DESIGN ADVISORY BOARD Tuesday May 10, 2016 at 3:00 PM Conference Room 12, City Hall, Burlington, VT Agenda

TO: Design Advisory Board
FROM: Scott Gustin *AD*
DATE: May 10, 2016
RE: 16-1145CA/MA, 207 Flynn Avenue

Request: Construct new retail grocery building and related site improvements and subdivide lot.

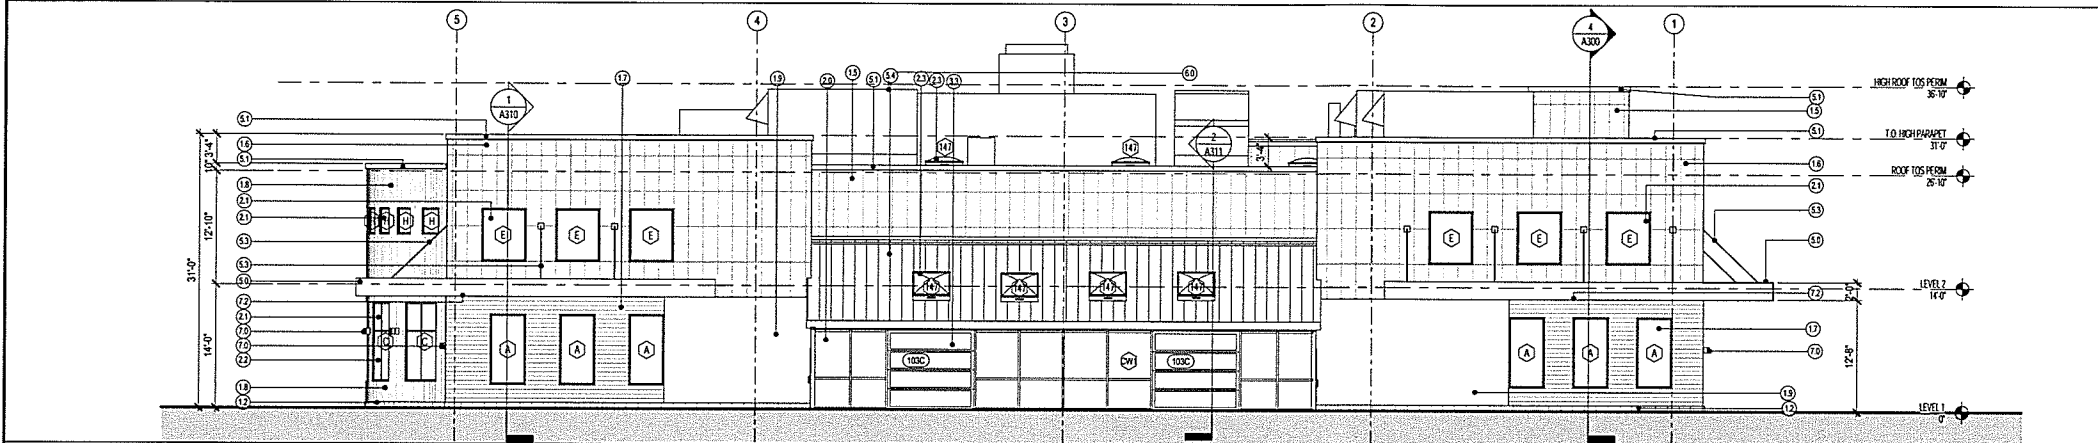
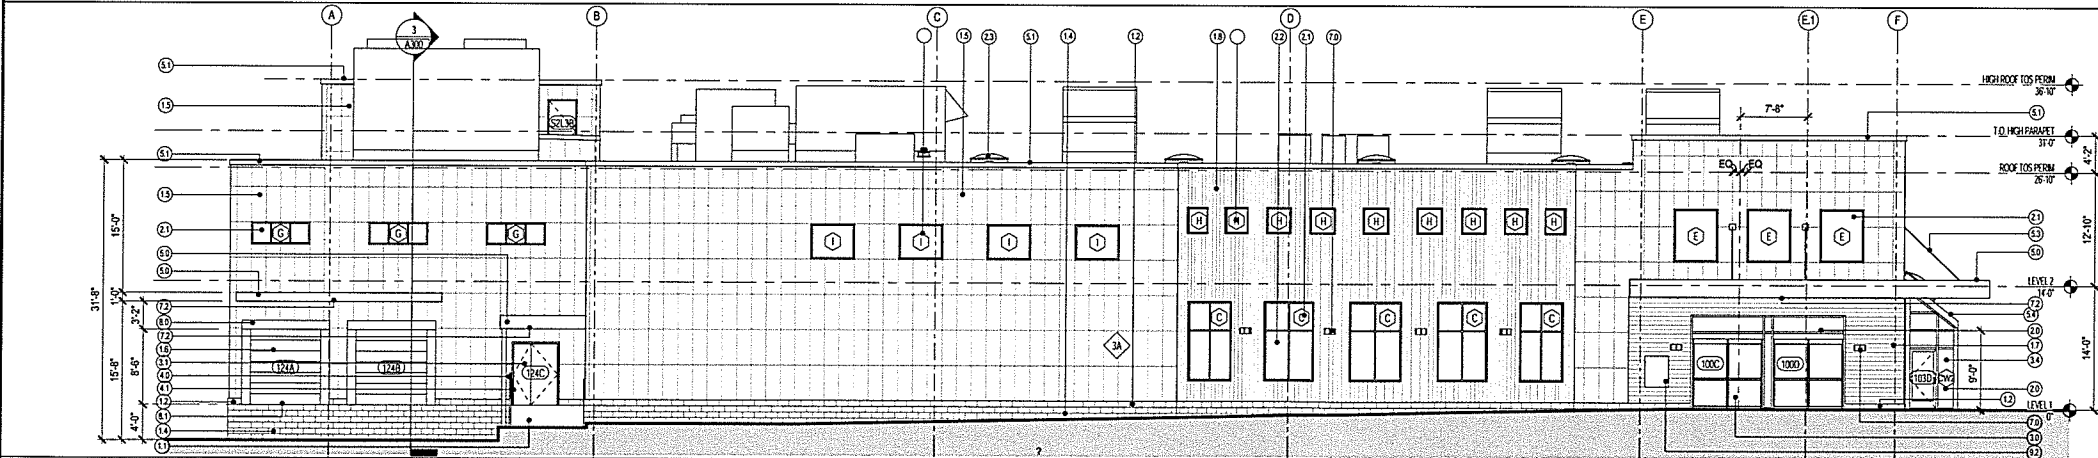
The north and east building elevations define this structure's street face. Both have well defined entries sheltered underneath a projecting canopy. Ample glazing along the Briggs Street façade provide visual access into the building. The café and related outdoor seating area provide additional activation. The Flynn Avenue façade is less successful as a pedestrian interface. Half of it contains an entry and mural sheltered under a canopy. These elements clearly draw people towards the building entry. The other half, however, is fairly blank. Interior store layout presumably drives the lack of ground-level glazing but there is room for improvement to further activate the street level of this primary building façade.

A parallel “City Market” sign is depicted on the Briggs Street building elevation. It appears to be placed above 14’ height. Such placement is acceptable so long as the sign is not internally illuminated. Sign area is ~ 57 sf, under the maximum permissible 200 sf.

6. Provide additional pedestrian activation of the Flynn Avenue façade.
7. Provide screening for all rooftop mechanicals and confirm whether mechanical units exceeding the overall 45’ height limit comprise 10% or less of the total rooftop area.
